ILLINOIS POWER COMPANY

May 25, 1984

Subject: Clinton Power Station Unit 1
SER Confirmatory Issue No. 71
Humphrey Concerns

Illinois Power Company letter dated June 17, 1983 (refer U-0644) addressed some of the John Humphrey concerns as applicable to the Clinton Power Station (CPS). Enclosed are CPS responses on some additional Humphrey issues for NRC Staff review. Included are Action Plans #5, 6, 8, 21 and revised responses to Action Plans #2 and 3. We believe that these responses will resolve the particular concern involved.

Figure 3-1: ENCROACHMENT MODIFICATION FOR CLINTON

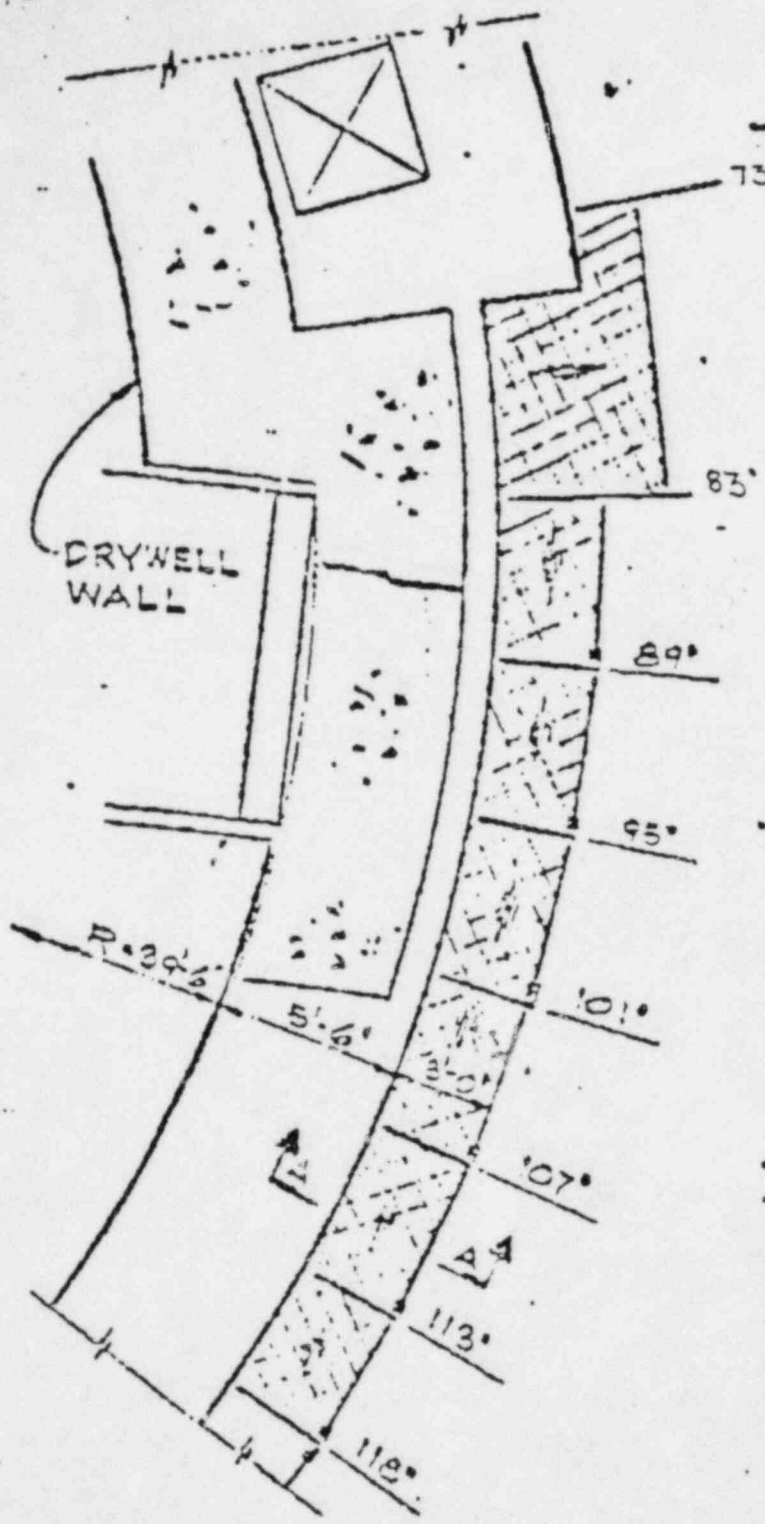
A new SOLAV01 analysis was performed in response to a design change to the encroachment of the CPS suppression pool. The encroachment was increased by replacing the existing grating with 1½" steel plate, as shown in Figures 3-1 and 3-2. The plate extension has the effect of diverting the water toward the outer portion of the containment, which prevents water slug impact on the HCU floor. Loads for various structural members of the HCU floor over the equipment and personnel hatches were calculated using FSAR pressure histories.

Figures 3-1 and 3-2 show the plate modification which extends three feet radially beyond the equipment hatch and personnel hatch, respectively. SOLAV01 predicts the worst-case pool swell to occur at the midpoint of the circumferential cross section of the encroachment that is the furthest from the clean pool.

Figure 3-4: CLINTON SUPPRESSION POOL SOLAV01 MESH

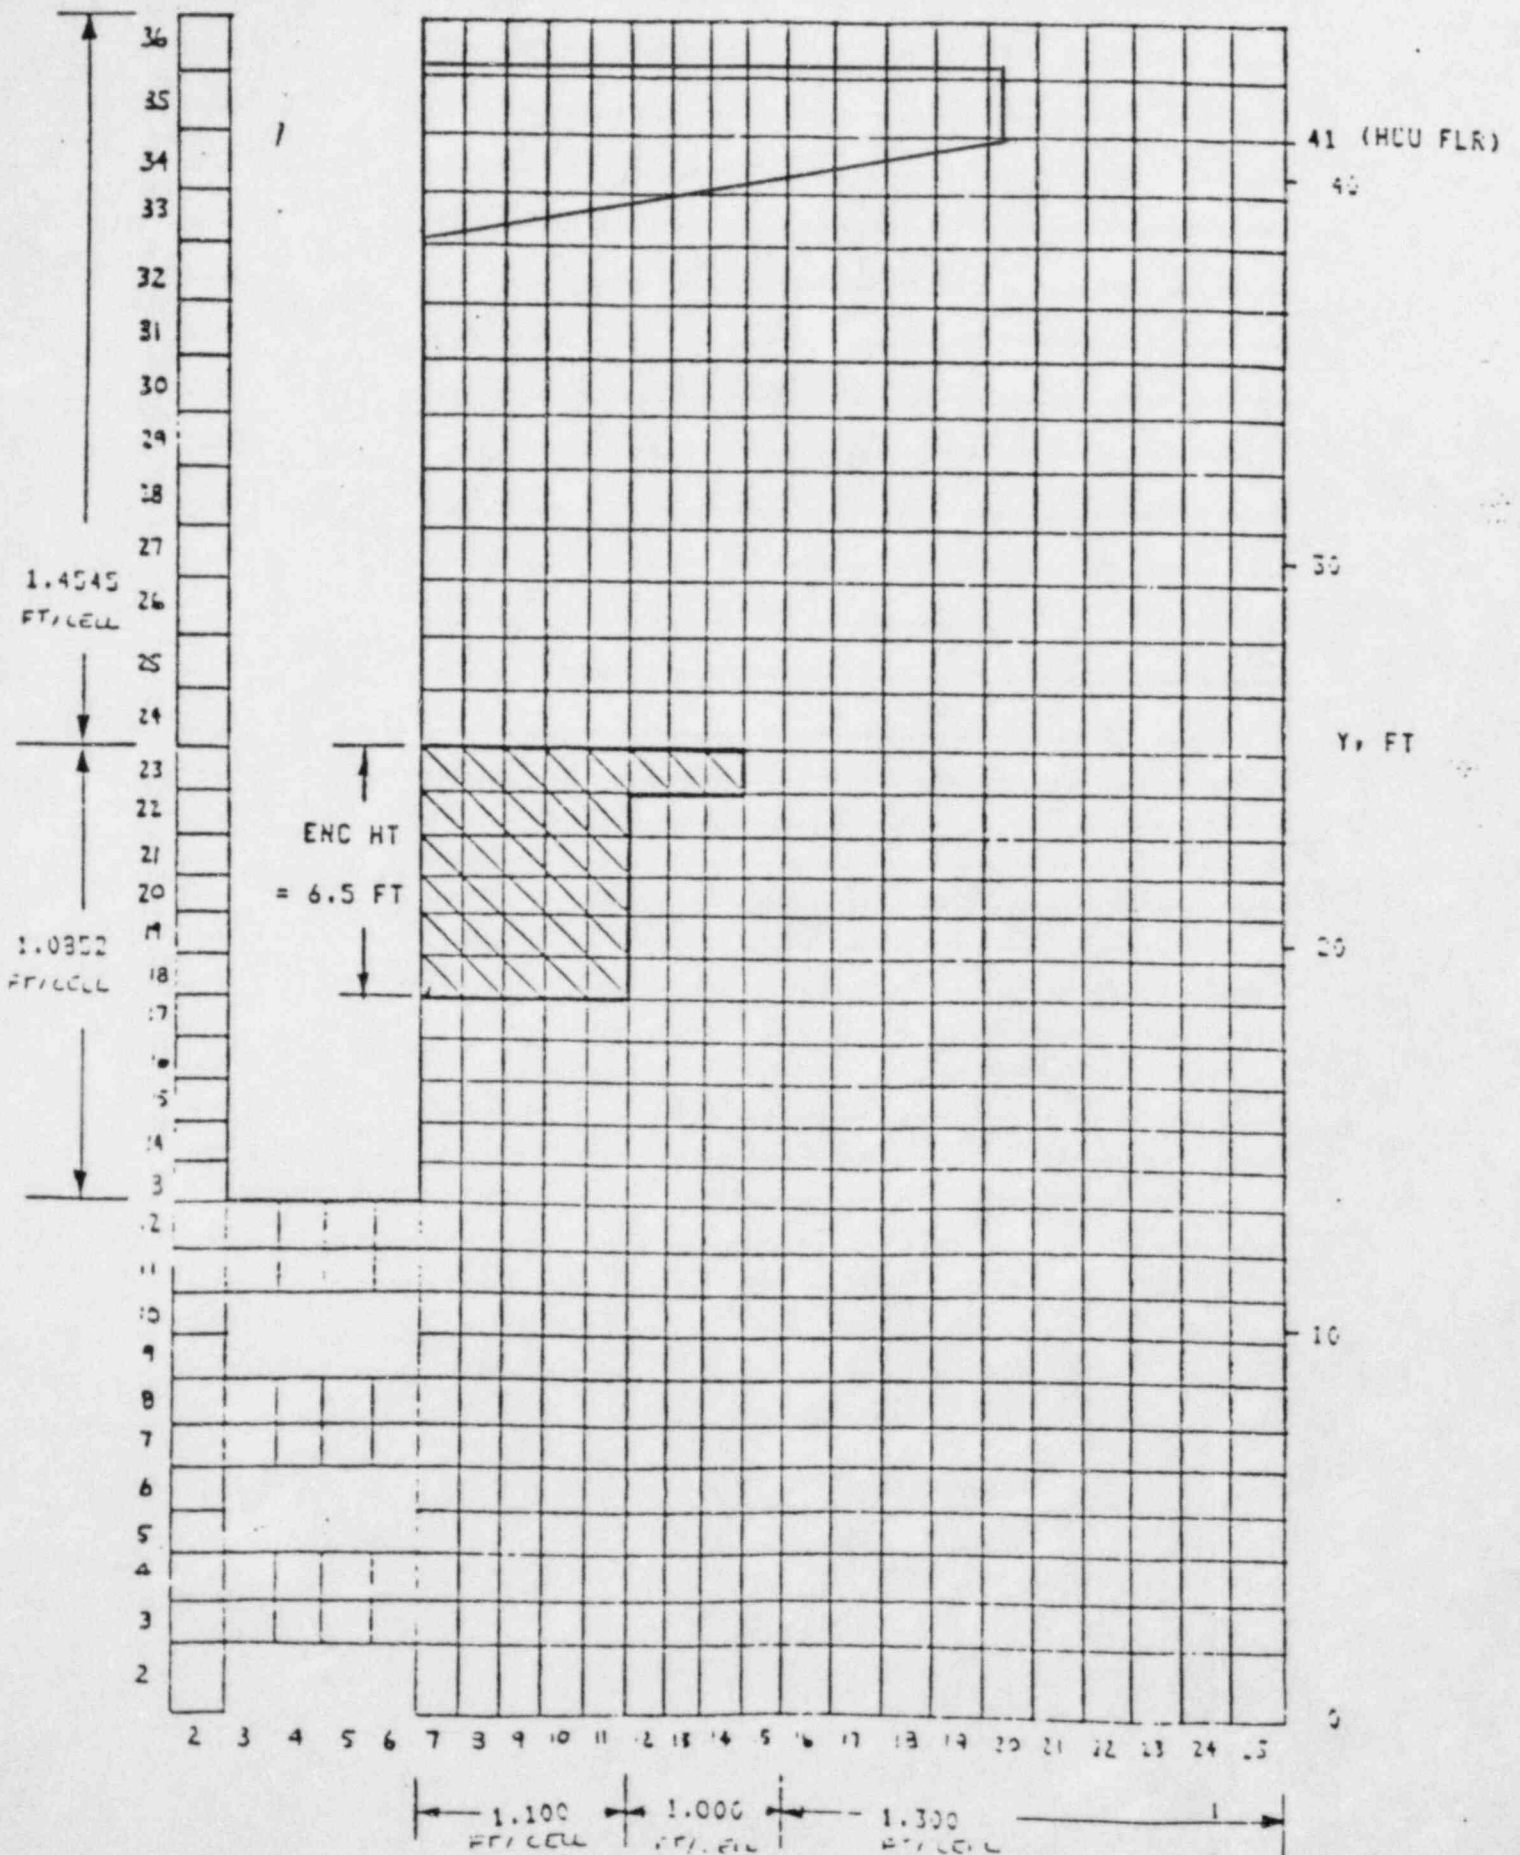
Figure 3-4 shows the resultant SOLAV01 mesh for the 5.5 foot encroachment plus 3-foot extension case. Figure 3-5 shows the resultant bubble pressure time history.

Figure 3-6: CLINTON FSAR ENCRANCED CASE POOL SIMULATION, PERSONNEL HATCH WITH PLATE EXTENSION

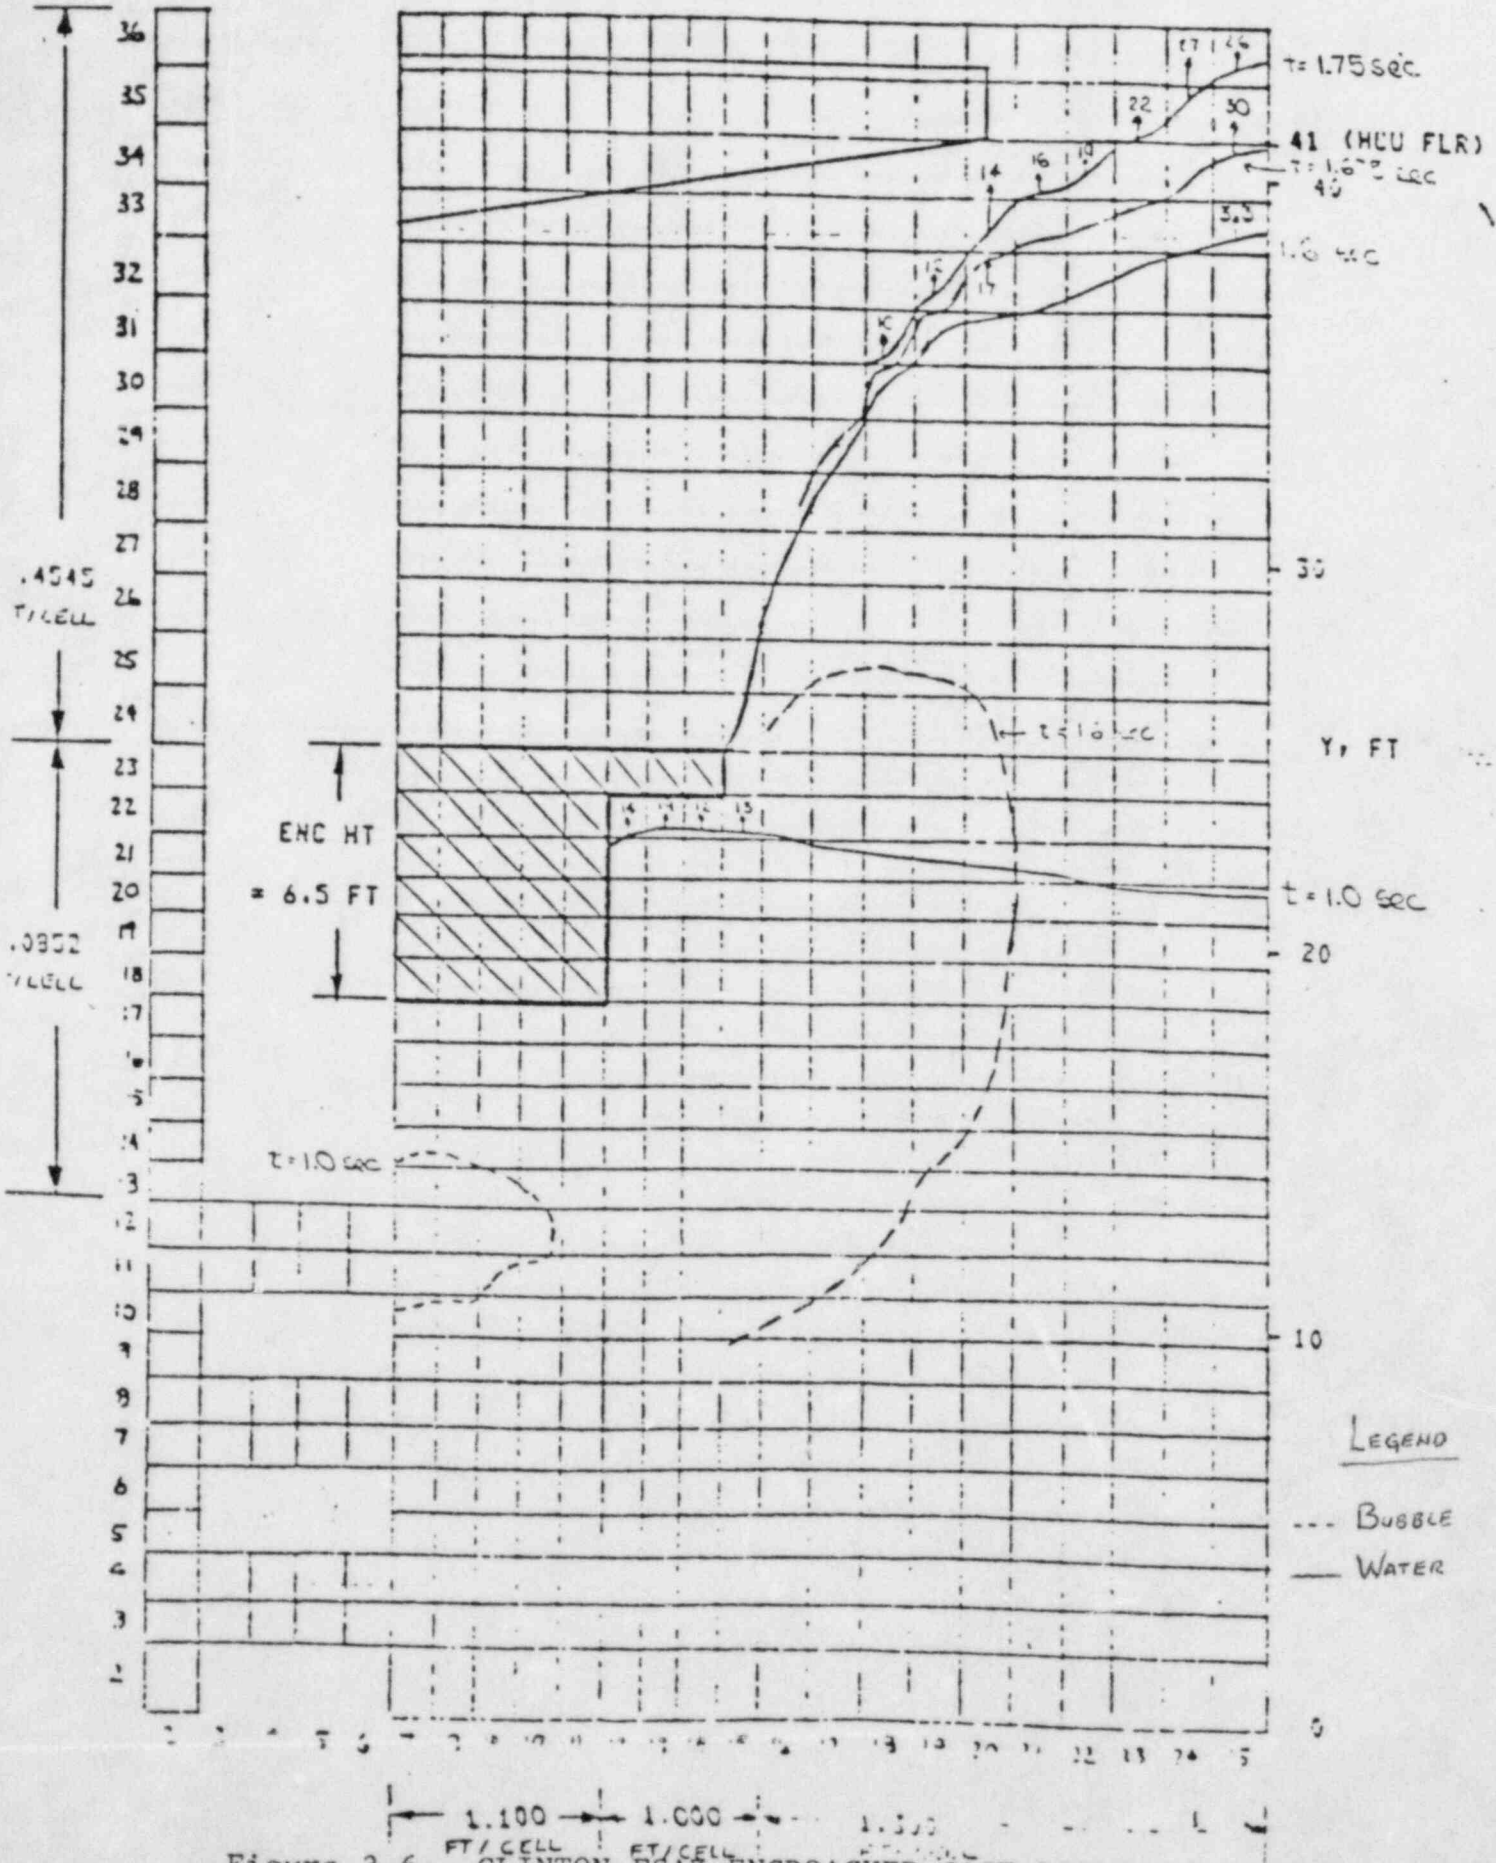
The analysis indicates that liquid impact does not occur on the concrete portion of the HCU floor and steam tunnel. Figure 3-6 shows how the bubble and pool surfaces grow.

Figure 3-7: CLINTON FSAR BASE CASE PRESSURE HISTORIES

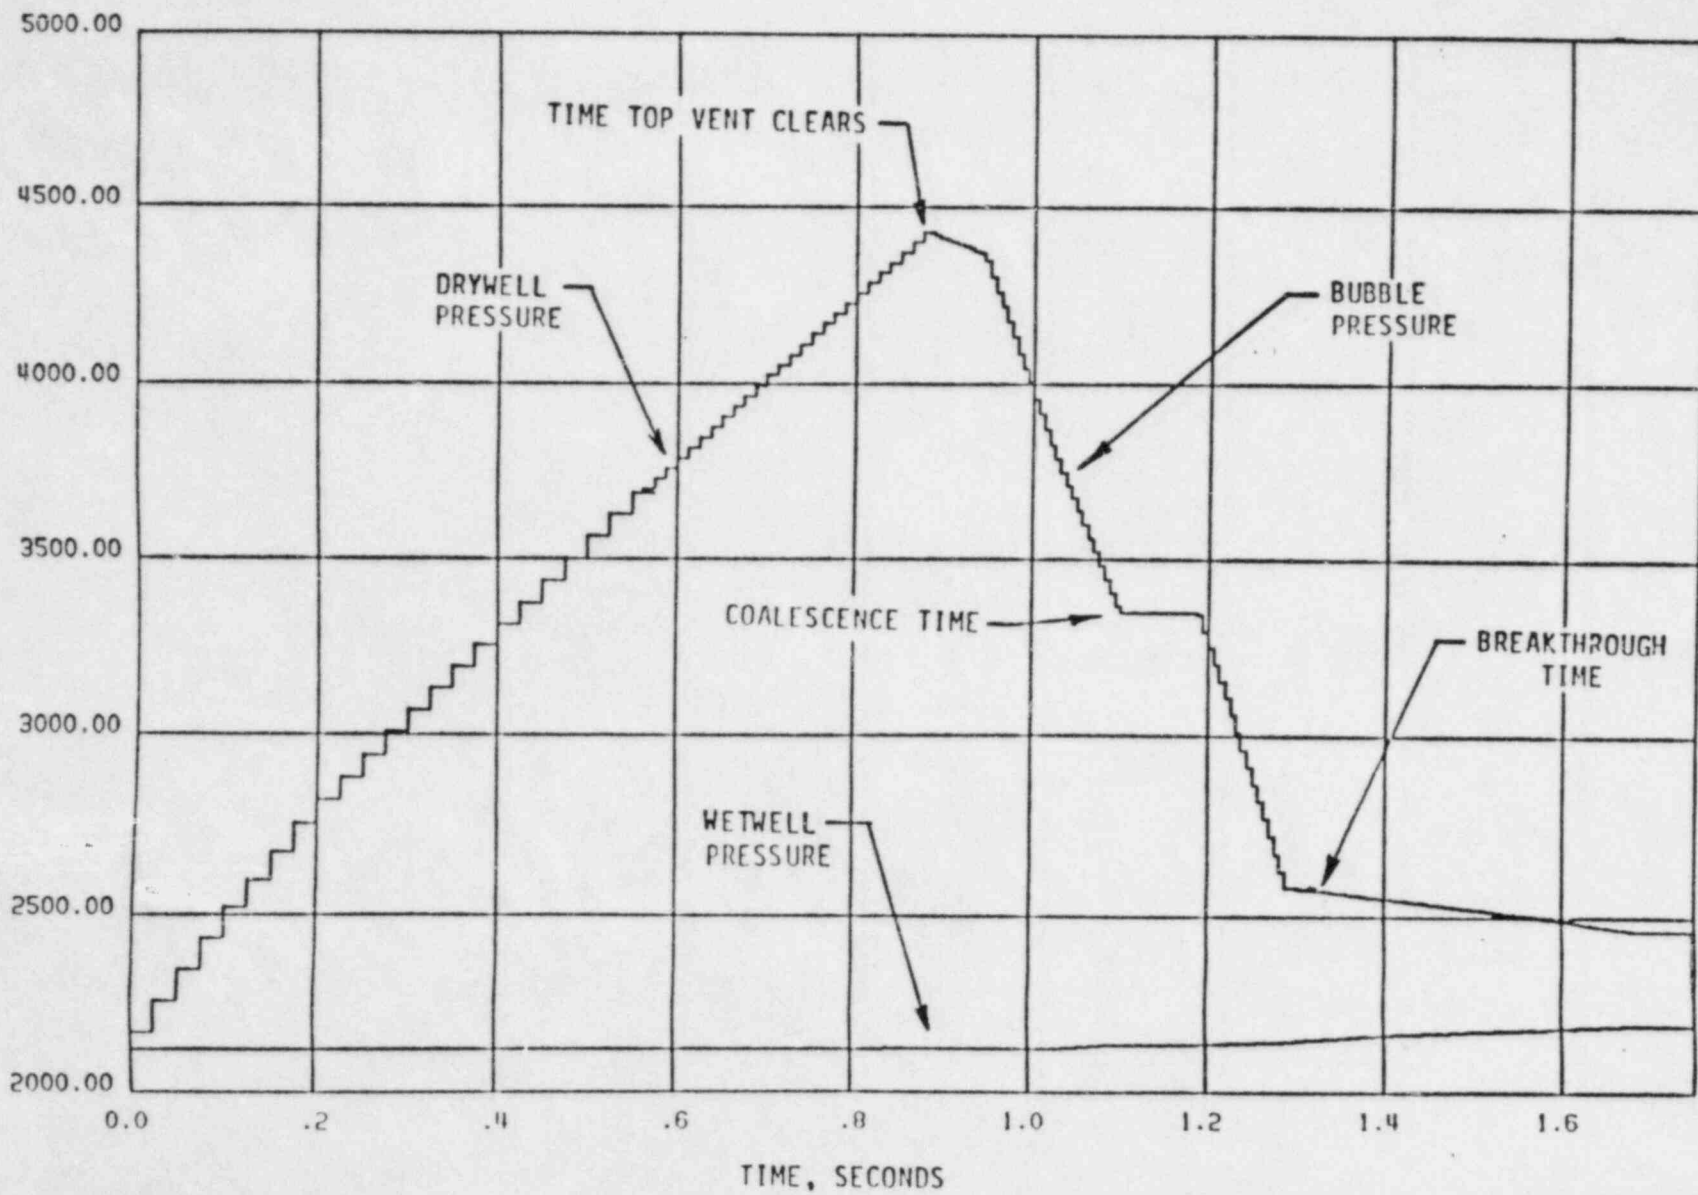
GE's containment response model was run for Clinton's new pool geometry using FSAR input assumptions to determine the drywell and wetwell pressure time histories (see Figure 3-7). The small decrease in open pool area has a negligible effect on the bulk pressure response.
